Soldier Creek Coal Company
HIDDEN VALLEY MINE

Subject: Amendments to Surface Mining and Reclamation Plan
Interim Program - Hidden Valley Mine

RE: Interim Program Mine Plan
Review of the Hidden Valley Mine.

Figure 1. Surface and groundwater monitoring stations.

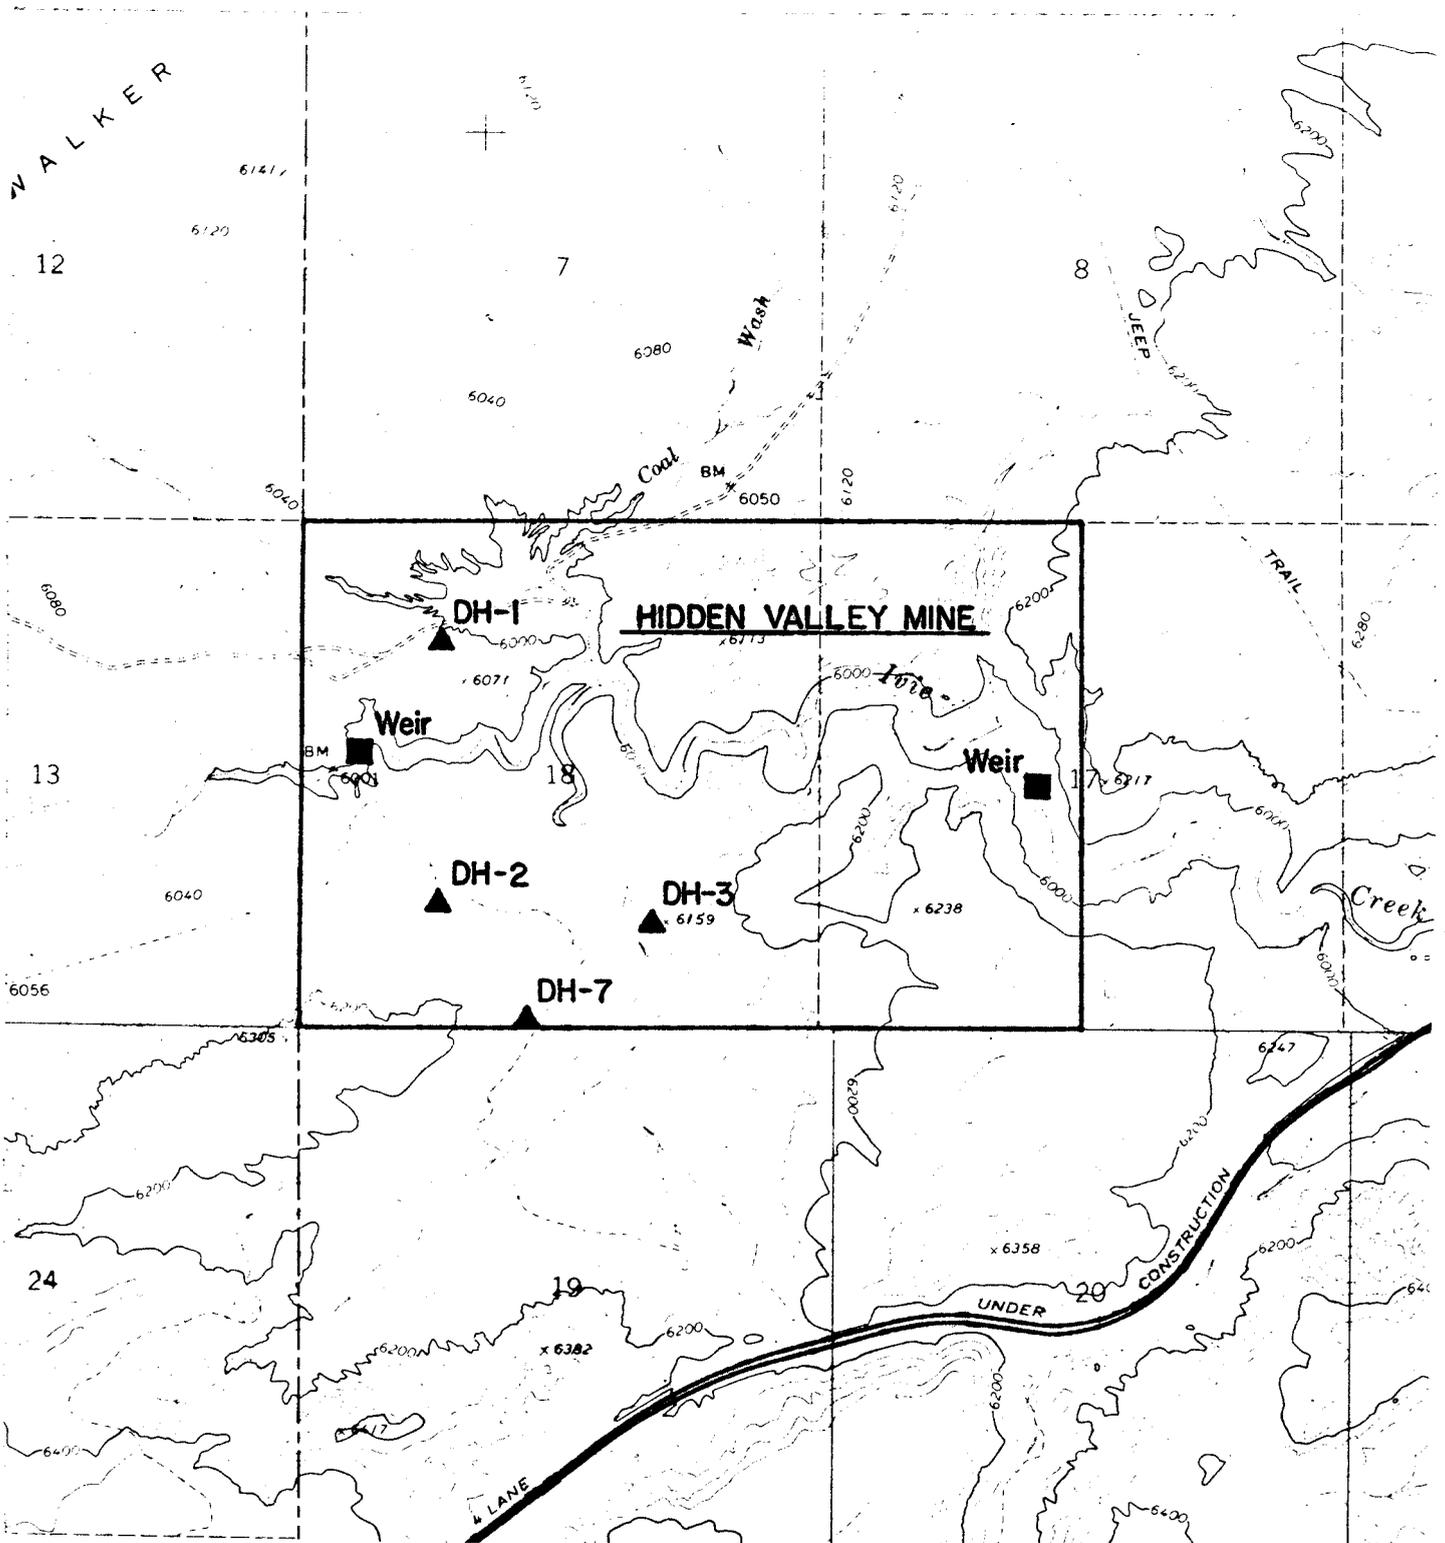
Please indicate on a map all surface and groundwater monitoring stations.

See Figure 1.

*Figure 2.
Typical Key Trench or Cutoff Trench Design for
Small Dams*

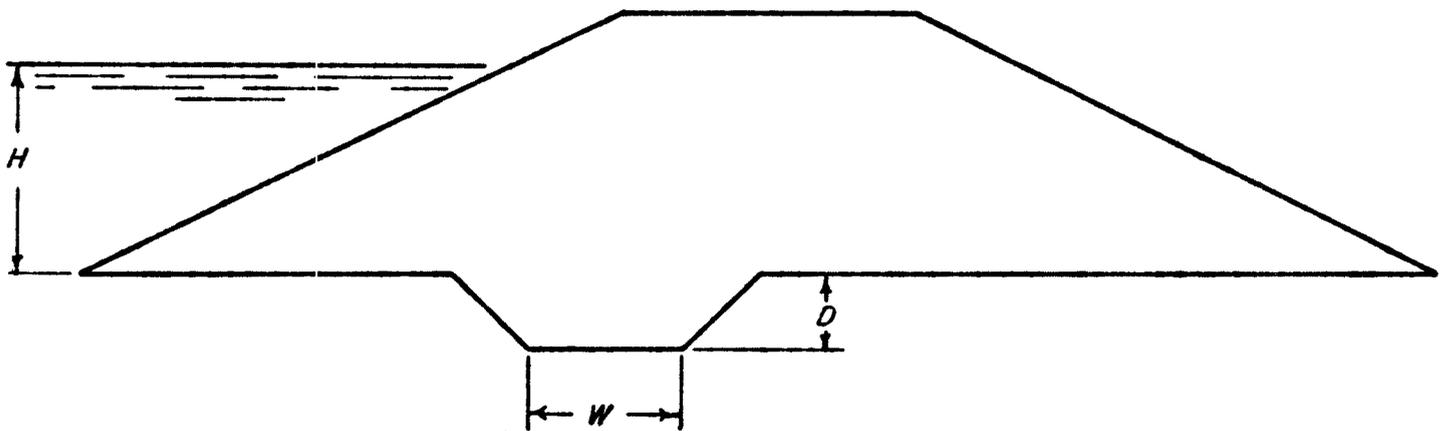
6. Pages 4-7 & 4-15: Cross-sections for the surface facility sedimentation pond embankment and refuse pile sedimentation pond embankment do not show Keyway cuts at the foundation interface. These will be required.

A typical Keyway design for small dams is shown in Figure 2. The following equation gives the relation used:

$$W = H - D$$

Where W is the bottom width of the trench; H is the reservoir head above the ground surface; and D is the depth of the trench excavation below the ground surface.

The above design will be incorporated into the construction plans for the surface facilities and refuse pile sedimentation dams. However, final design may vary somewhat due to site specific conditions encountered.

Figure 3. Proposed surface facility soil stockpiling area. Revision of Appendix B of the Mining and Reclamation Plan.

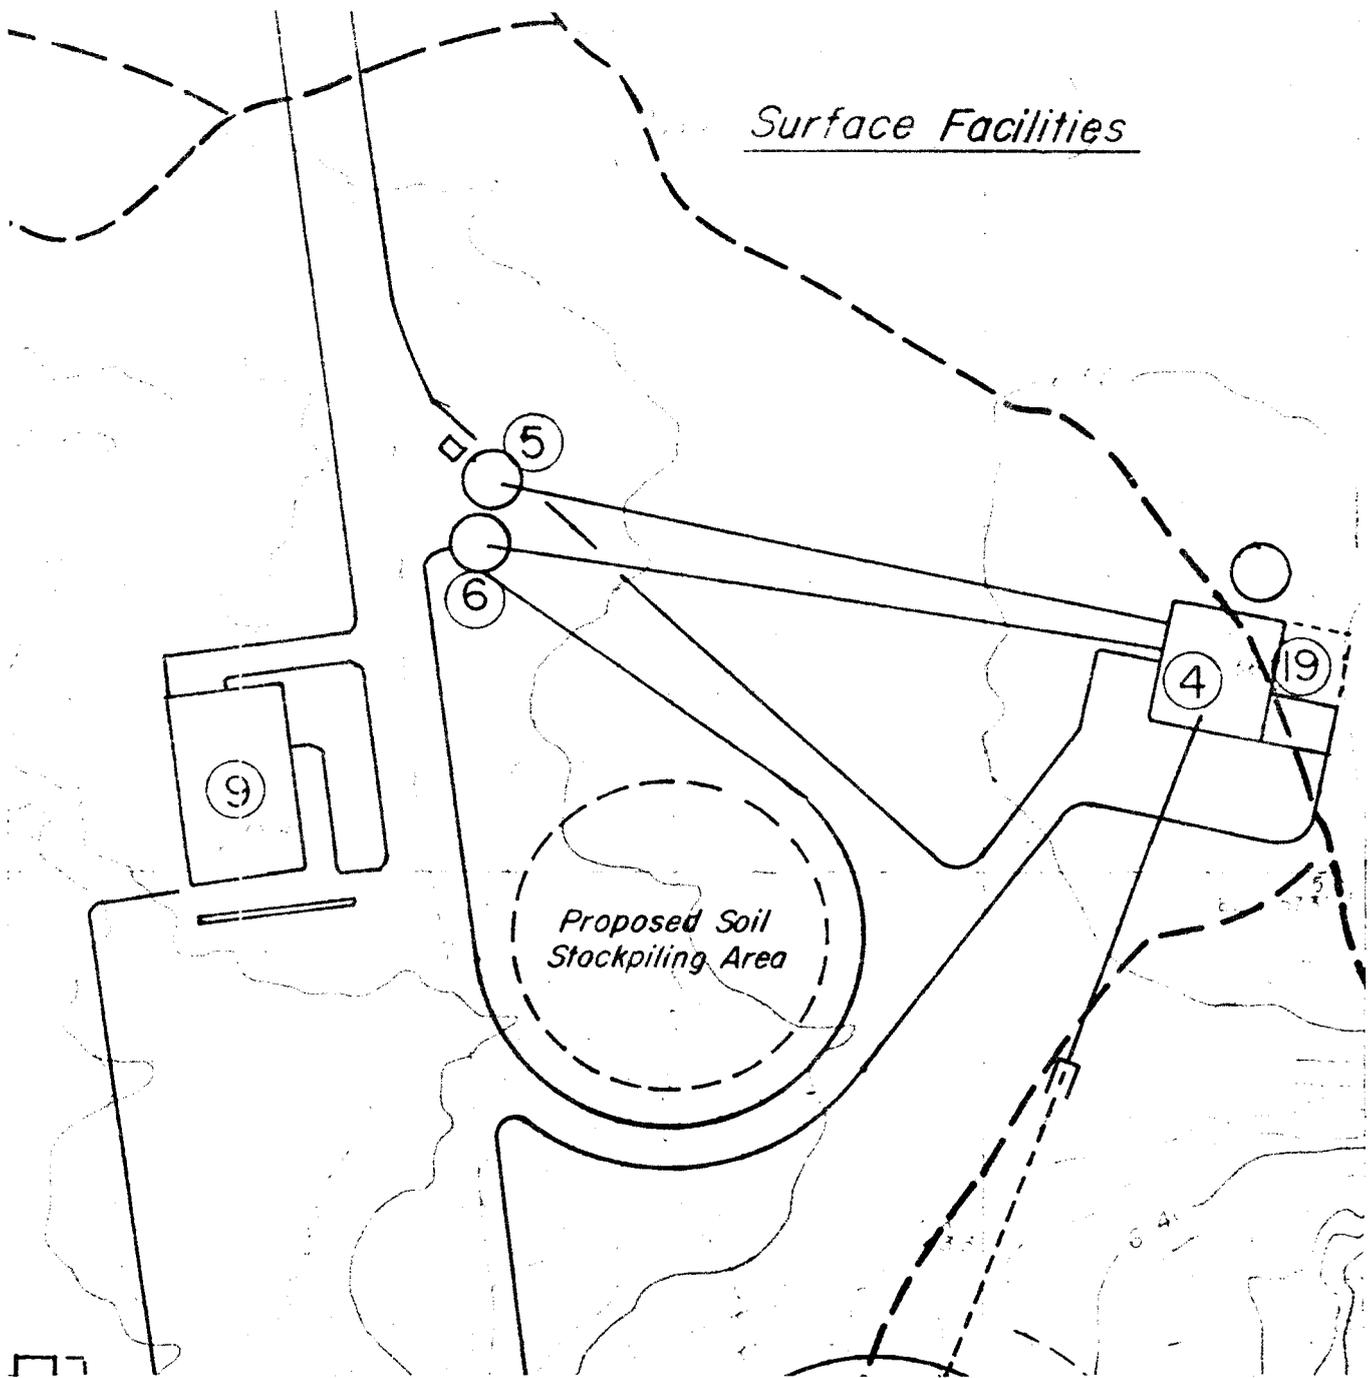
Please submit a map showing locations of all topsoil stockpiles and specific measures to be taken for protection of the stockpiles.

The proposed stockpile location for the surface facility area is shown in Figure 3. Stockpiles in the refuse disposal area will be very temporary and located where they will best complement reclamation work.

Stabilization and protection of stockpiled soils will be accomplished by establishing an effective vegetative cover. Temporary stockpiles may require little or no stabilization, depending on the amount of time needed before redistribution.

HIDDEN VALLEY MINE
PROPOSED MINE LAYOUT

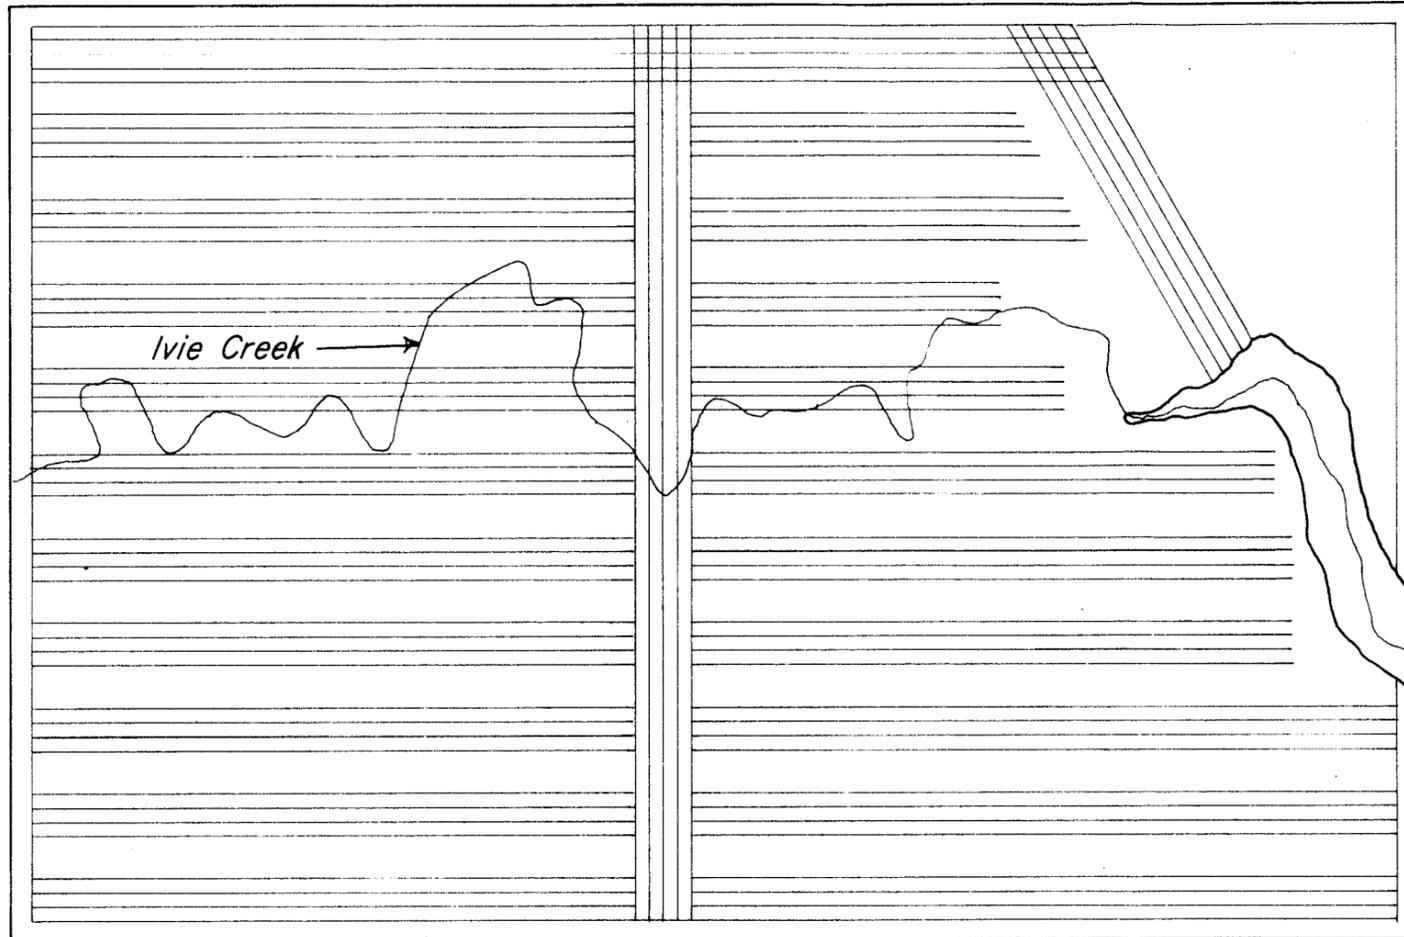
9. Page 6-1: The Division cannot approve the project without a mining plan. The mining plan affects the development of a subsidence monitoring plan and the groundwater monitoring plan. In addition, surface effects of underground mining may require certain areas to be left supported. The Division will require a subsidence monitoring program for this project.

The proposed mine layout is shown in Figure 4. Also a proposed subsidence control plan is presented as Appendix A'. Subsidence control buffer zones will be maintained to adequately safeguard designated surface areas. These areas will include selected man made structures and natural features which are vital to the environmental balance.

Hidden Valley Mine currently has the capability to monitor any subsidence which might occur on the property. All necessary subsidence control points have been properly installed, and their locations are indicated in Appendix A'. Standard photogrammetric methods can now be used to determine the extent of any subsidence which may occur due to mining activity.
